**CONTRACT DE-AC24-01OH20115, TRANSMITTAL OF REVISED GRADING PLANS AND RESPONSES TO OHIO ENVIRONMENTAL PROTECTION AGENCY COMMENTS ON THE AREA 6 – FORMER PRODUCTION AREA MAIN DRAINAGE CORRIDOR FIRST AND SECOND STREETS, AND AREA 5**

# RESPONSES TO
# OHIO ENVIRONMENTAL PROTECTION AGENCY
# COMMENTS ON THE
# AREA 6 FORMER PRODUCTION AREA MDC
# FIRST AND SECOND STREETS, AND
# AREA 5 RESTORATION GRADING PLANS

# OHIO ENVIRONMENTAL PROTECTION AGENCY
# COMMENTS ON THE AREA 6 FORMER PRODUCTION AREA MDC FIRST AND SECOND STREETS, AND AREA 5 RESTORATION GRADING PLANS

DRAWING TITLE
AREA 6 (FPA), MDC-FIRST AND SECOND ST., AREA 5
RESTORATION GRADING PLAN
SHEET 1 OF 4

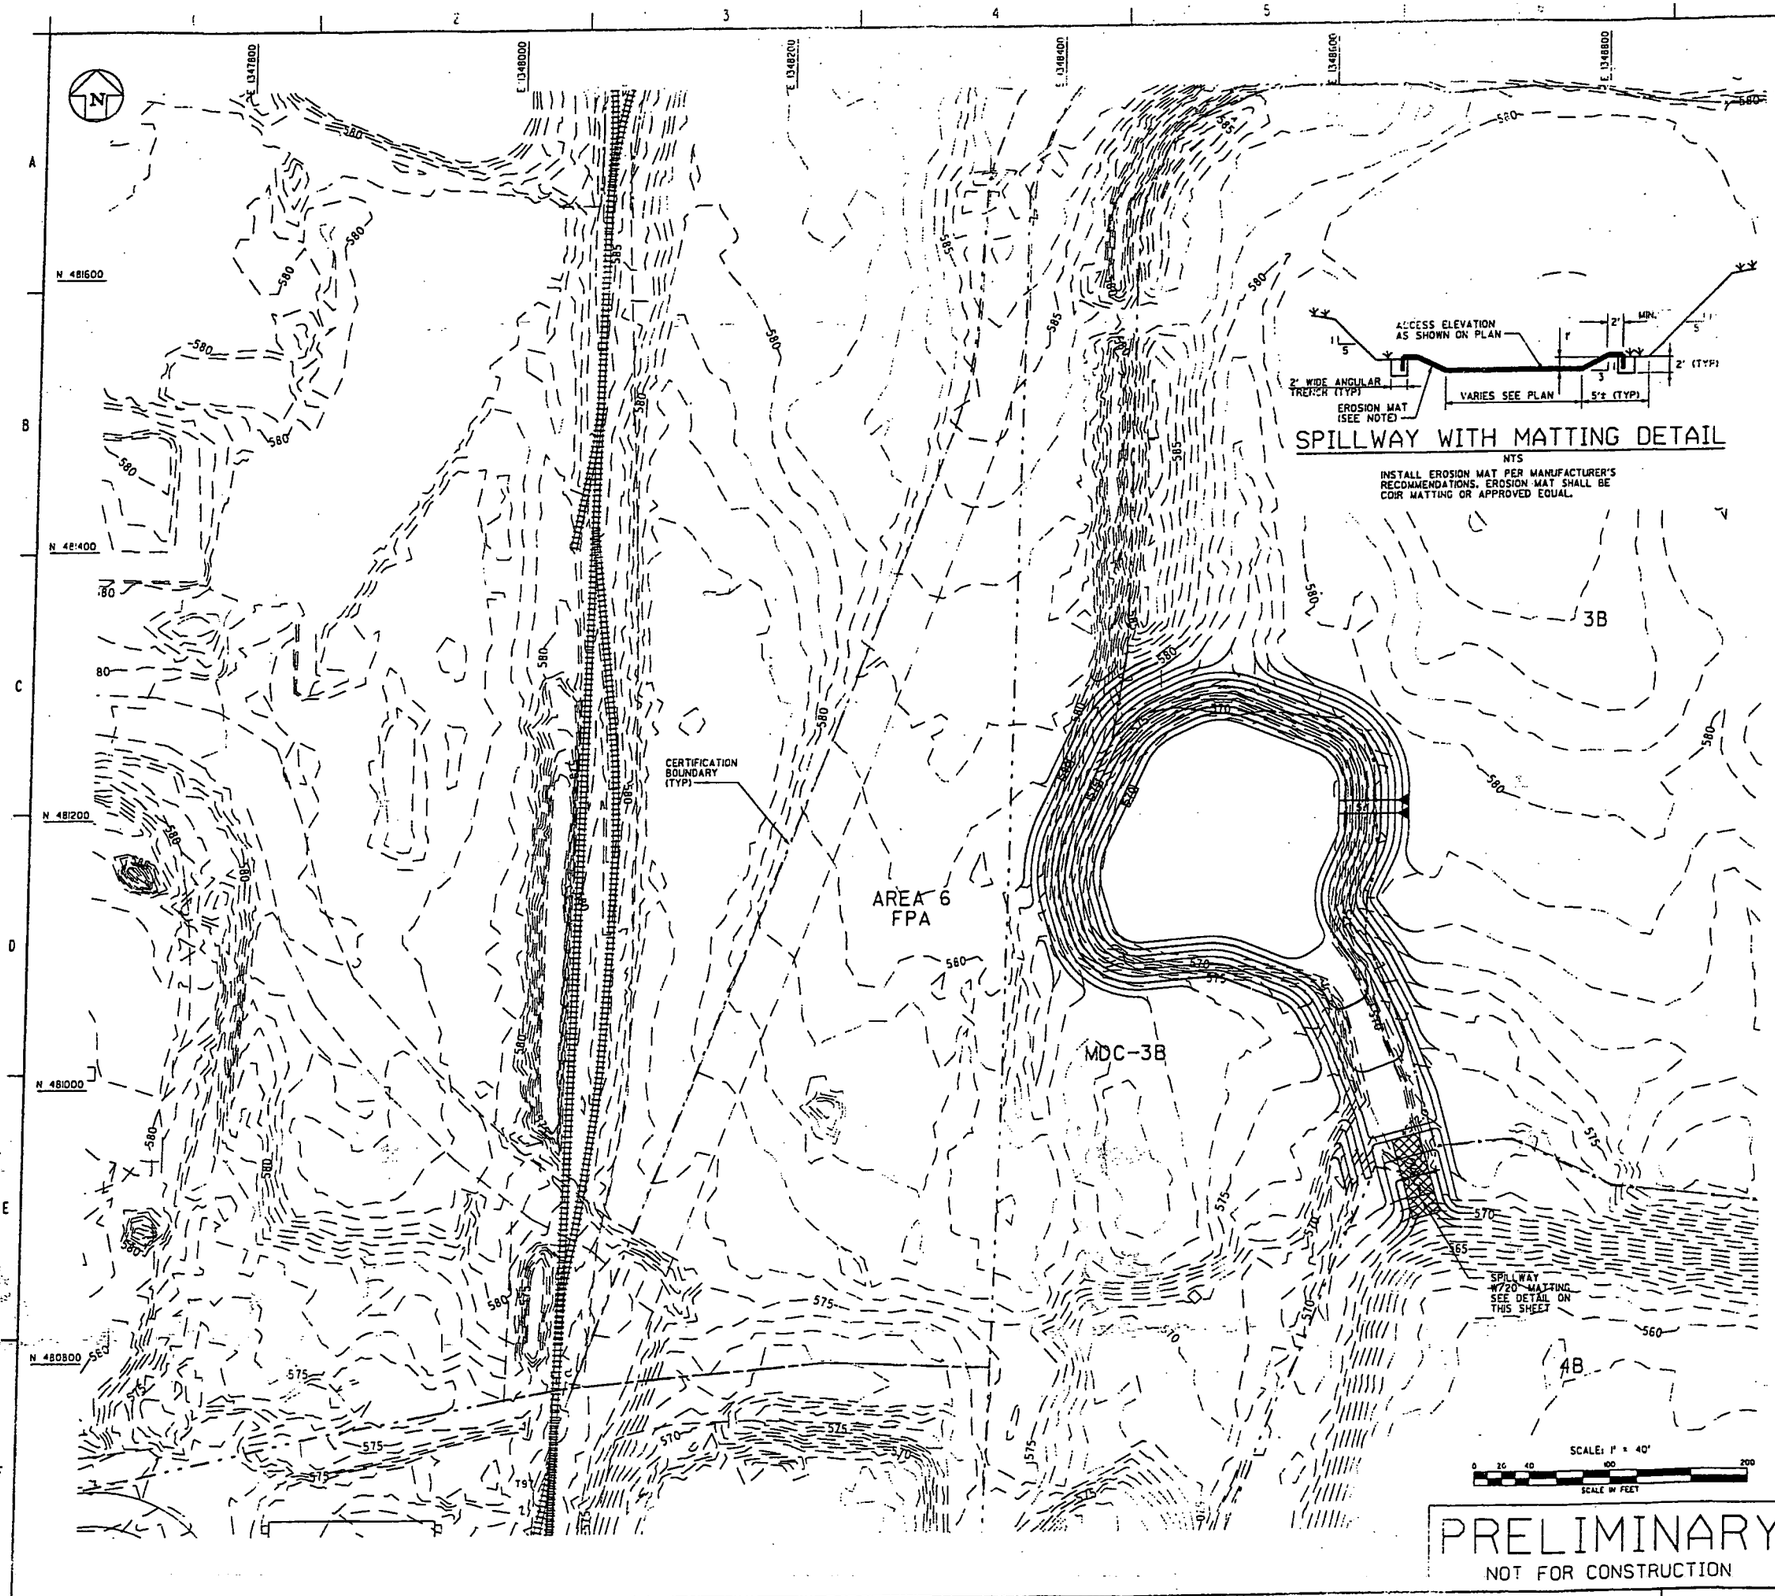
1. Commenting Organization: Ohio EPA Commenter: DSW
Section #: Drwg 99X-5500-G-00936 Pg #: Line #: NA Code: C
General Comment #: 1
Comment: The drawing shows what appears to be a gall bladder and bile duct. The long narrow pool bottom draining to the south could be changed so that it increases and decreases gradually in elevation. Doing so will allow the outlet to be a grass swale as gradient could be greatly reduced.
Response: This pool is designed to pond water to 3 feet in height from elevation 569 to 572 before it flows through a spillway to the south. The stem of the pond can be graded to allow a more gradual rise in the pond prior to discharge.
Action: Revise grading in stem of pond to reduce gradient.

DRAWING TITLE
AREA 6 (FPA), MDC-FIRST AND SECOND ST., AREA 5
RESTORATION GRADING PLAN
SHEET 3 OF 4

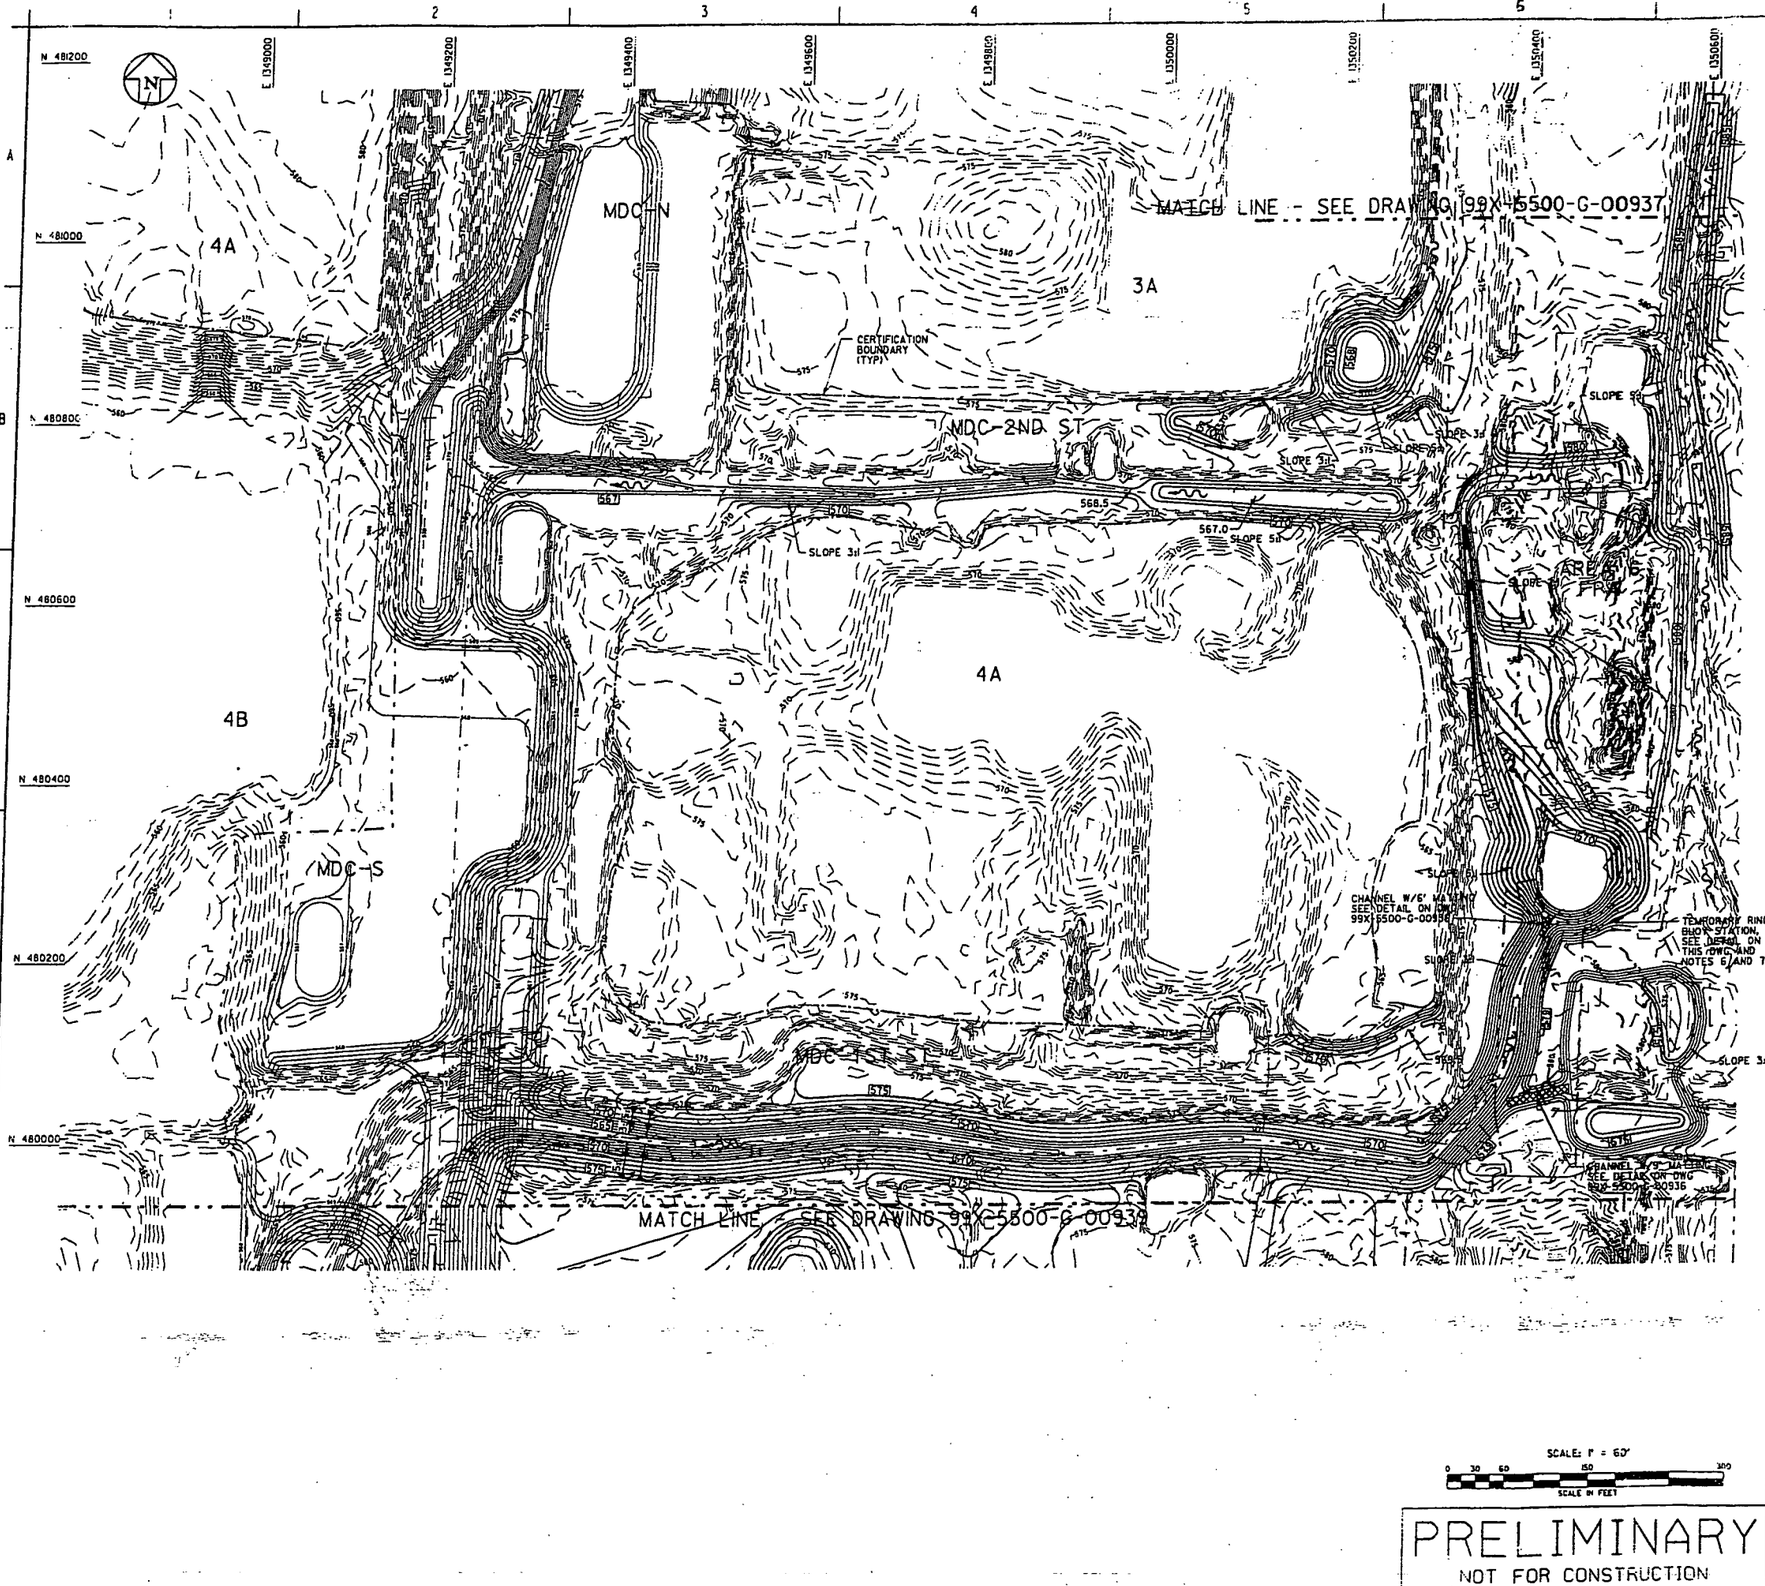
2. Commenting Organization: Ohio EPA Commenter: DSW
Section #: Drwg 99X-5500-G-00938 Pg #: Line #: NA Code: C
General Comment #: 2
Comment: This pool (eastern side of drawing) also has very unnatural contours. The sides could be changed to have a less engineered appearance and have some irregularity to them. It is also unclear how the water will flow into and out of this pool. If the flow is to the south, it would appear as though there should be some outlet structure installed.

Response: The pool will be re-contoured to more of a teardrop shape for more natural contouring. The pool is designed as a staged discharge. When the water elevation exceeds the maximum height of 577.0, the flow discharges by spillway to feed the Second Street ditch.
Action: The pool will be re-shaped to a less engineered appearance. The spillway width will be enlarged and spillway protection added. There will be no outlet structure installed.

DRAWING TITLE
AREA 6 (FPA), MDC-FIRST AND SECOND ST., AREA 5
RESTORATION GRADING PLAN
SHEET 4 OF 4

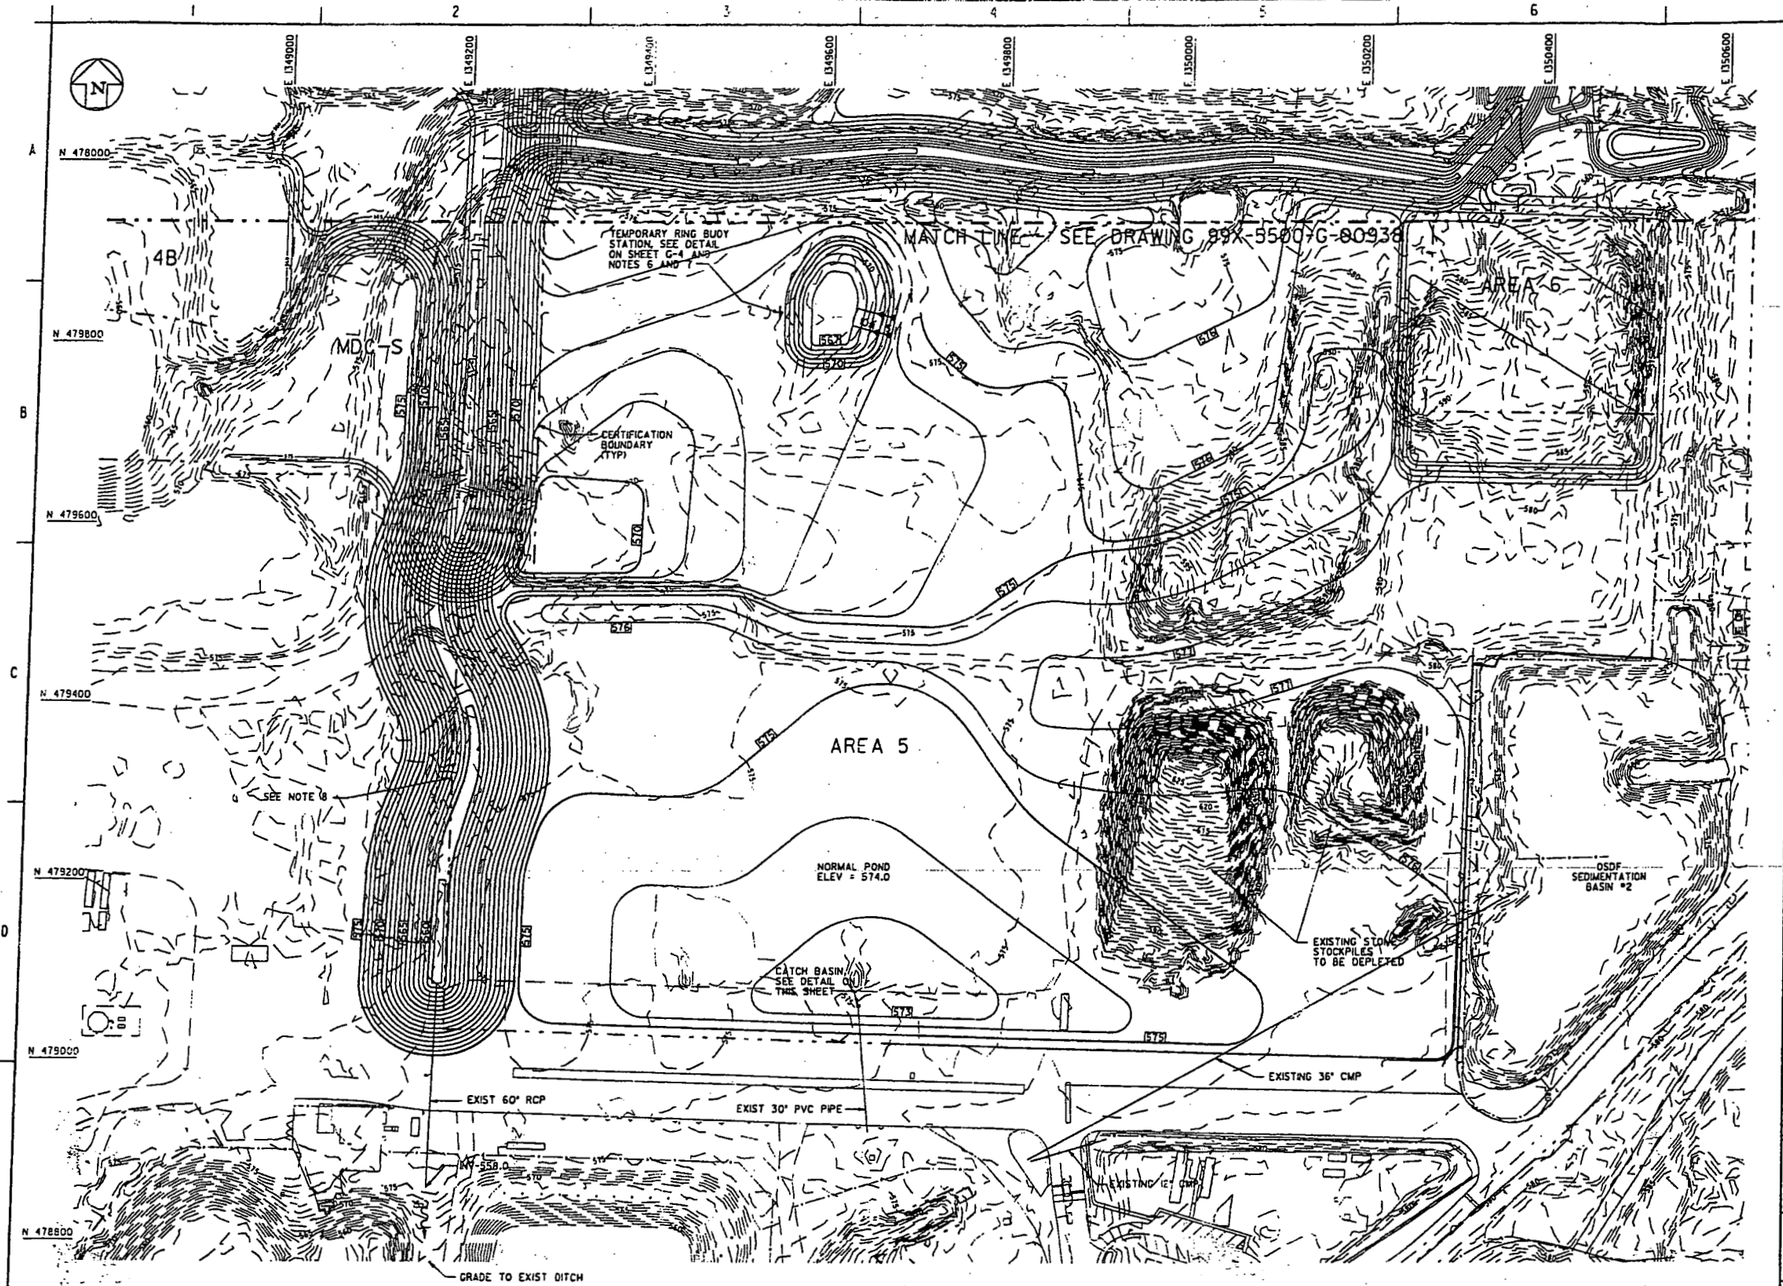
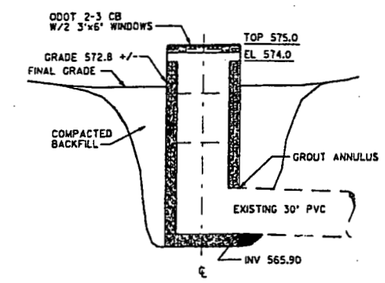
3. Commenting Organization: Ohio EPA Commenter: DSW
Section #: Drwg 99X-5500-G-00939 Pg #: Line #: NA Code: C
General Comment #: 3
Comment: Contours should be added to the big ditch, by making the flow path sinuous, it will look more natural and have a natural flow path. Following a 2-stage ditch design at a minimum is recommended. Also, it is not clear to which area the catch basin detail refers. It appears as though the basin in which it will be installed will not dewater and the catch basin hold water normally. If that is true, the basin to which this will pertain should show the high water level.
Response: The ditch west of Area 5 can be re-contoured with a sinuous path. This ditch will flow into an existing 60" culvert to the SSOD area. This ditch is already designed with 2 stages. The ponds north of this ditch do not feed to this ditch until the elevation exceeds 563.0.

The catch basin is shown on the plan view at the low point of Area 5. This catch basin is designed to pond water in Area 5 to approximately 1.2 feet in height before it flows through the windows of the catch basin. A second stage on the catch basin allows additional flow to discharge when the pond elevation reaches an approximate 2.2 foot height.
Action: The ditch west of Area 5 will be re-contoured with a sinuous path. A normal pond elevation will be shown on the drawings near the catch basin.
